Richard L. Anderson
Vice President-Nuclear440-280-5579
Fax: 440-280-8029December 7, 2004
PY-CEI/NRR-2846LUnited States Nuclear Regulatory Commission
Document Control Desk
Washington, DC 20555Perry Nuclear Power Plant
Docket No. 50-440
Responses to Requests for Additional Information Regarding In-Service Examination
Program Relief Requests IR-050, IR-051, and IR-052 (TAC Nos. MC3169, MC3170 and
MC3171)

**RESPONSES TO REQUESTS FOR ADDITIONAL INFORMATION REGARDING
PERRY NUCLEAR POWER PLANT IN-SERVICE EXAMINATION PROGRAM
RELIEF REQUESTS IR-050, IR-051 AND IR-052**

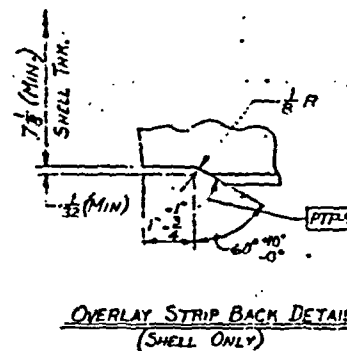
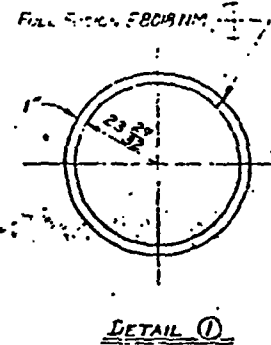
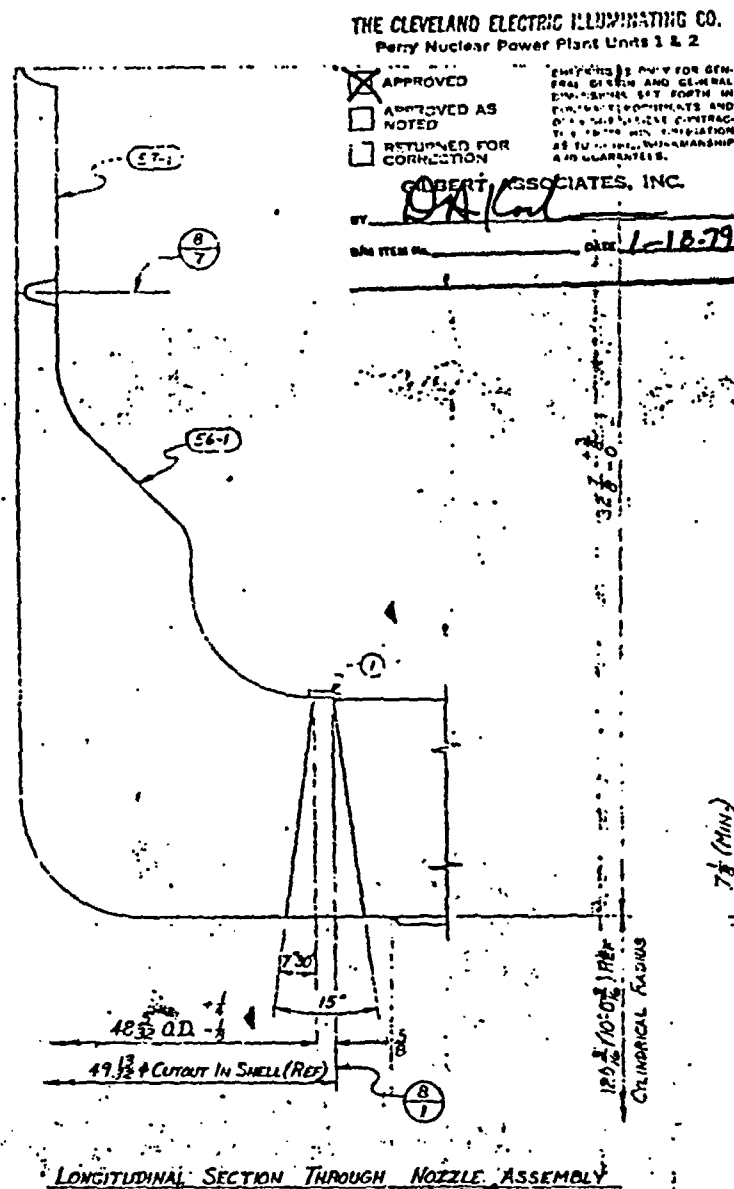
In accordance with guidance provided to staff for review of relief requests, provide detailed drawings which depict the examination volume that has been examined during previous inspections and the proposed examination volume. The weld sketches should show the exact dimensions of the as installed welds and the positions of any repairs to those welds so that the licensee will be able to precisely locate the extremities (widest sections) of the nozzle-to-vessel welds and any repair weld areas so that the new examination volumes will encompass these repair weld areas.

- (a) Discuss the documentation available of the actual cross-sectional dimensions and precise locations of repaired areas for all RPV nozzle-to-vessel welds at PNPP. Discuss the process for defining new examination volumes that encompass these repair weld areas.
- (b) If examination personnel are to identify the extremities (widest sections) of the nozzle-to-vessel welds, what positive means of examination will be used to identify the weld extremities, such as, weld etching, etc.? Will the weld extremities be identified on both the inside diameter and outside diameter of the vessel to ensure complete coverage of the welds?

As stated in IR-052, all of the PNPP's nozzles are of the configuration depicted by ASME XI Figure IWB-2500-7(b). The PNPP's vessel was fabricated by Chicago Bridge and Iron – Nuclear (CBIN). Attachment 2 provides the CBIN drawing for the Main Steam Nozzle-to-Vessel weld and mark-ups of that weld configuration denoting the current ASME XI required coverage and the proposed coverage. This configuration is typical of all of the subject nozzle-to-vessel welds.

Since fabrication, there have been no repairs to any of the PNPP's nozzle-to-vessel welds. Detailed records of the in-process repairs that were made to the nozzle-to-vessel welds during fabrication are not available. Until such time that the Nuclear Regulatory Commission (NRC) staff formally approves Code Case N-613-1, to ensure that the in-process repairs are encompassed in the examination areas, the PNPP staff will extend the Code Case N-613-1 examination volume out from ½ inch on either side of the weld to 1 inch on either side of the weld (see Attachment 2).

All of the subject nozzle-to-vessel welds were made using the Submerged Arc Welding method with the root of the weld being on the outside of the vessel and the face of the weld being on the inside of the vessel (see Attachment 2). As such, the widest section of the weld is not visible to the examination personnel. Complete coverage is determined by calculating the weld width from the drawings and scanning the appropriate distance on either side of the weld centerline, which was marked with punch marks by CBIN when the vessel was fabricated.
